ENVIRONMENTAL REVIEW COMMITTEE REPORT

ERC MEETING DATE:	September 15, 2014
Project Name:	Copperwood Preliminary Plat
Project Number:	LUA14-000550, PP, ECF, MOD
Project Manager:	Rocale Timmons, Senior Planner
Owner:	Various (Exhibit 10)
Applicant:	Barbara Rodgers; Quadrant Corp; 14725 SE 36 th St, Suite 100; Bellevue, WA 98006
Contact:	Wayne Potter; Novastar Development, Inc.; 18215 72 nd Ave S; Kent, WA 98032
Project Location:	4905 SE 2 nd P./355 Field Pl SE/4921 SE 2 nd Pl./312 Field Pl SE/5001 SE 2 nd Pl./5013 SE 2 nd Pl./14217 SE 136 th St.
Project Summary:	<p>The applicant is requesting SEPA Environmental Review, Preliminary Plat approval, and a street modification for a 47 lot subdivision. The subject property is a collection of eight parcels located on the south side of SE 2nd Place between Field Place SE and 143rd Ave SE. The applicant is requesting a concurrent Lot Line Adjustment (LUA14-000730) to three of the subject parcels, and an abutting parcel, in order to define the Preliminary Plat boundaries. The resulting 12.68-acre site is located within the Residential-4 dwelling units per acre (R-4) zoning classification. The 47 lots would result in a density of 4.44 dwelling

PRIMARY LANDSCAPE PLAN
FOR
COPPERWOOD

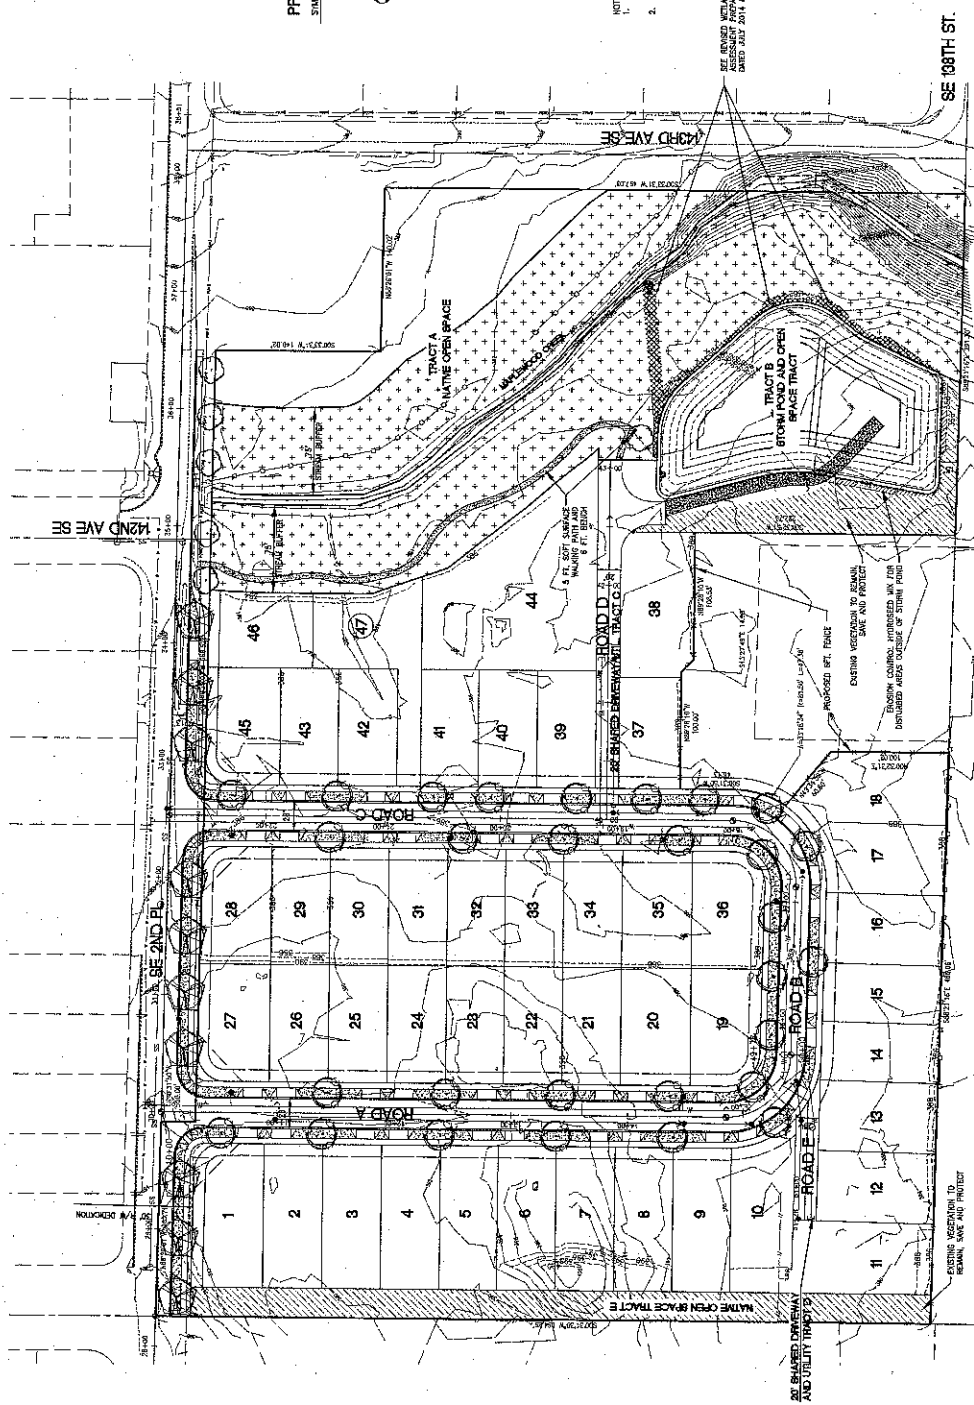
The applicant also provided a conceptual landscape plan as part of the Preliminary Plat submittal which included the planting of 45 trees on site (Exhibit 3). Conditions associated with Preliminary Plat approval will likely include the provision of a 10-foot wide on-site landscaping along the street frontage of all lots and the planting of additional vegetation along the western boundary in order address privacy concerns of interested parties.
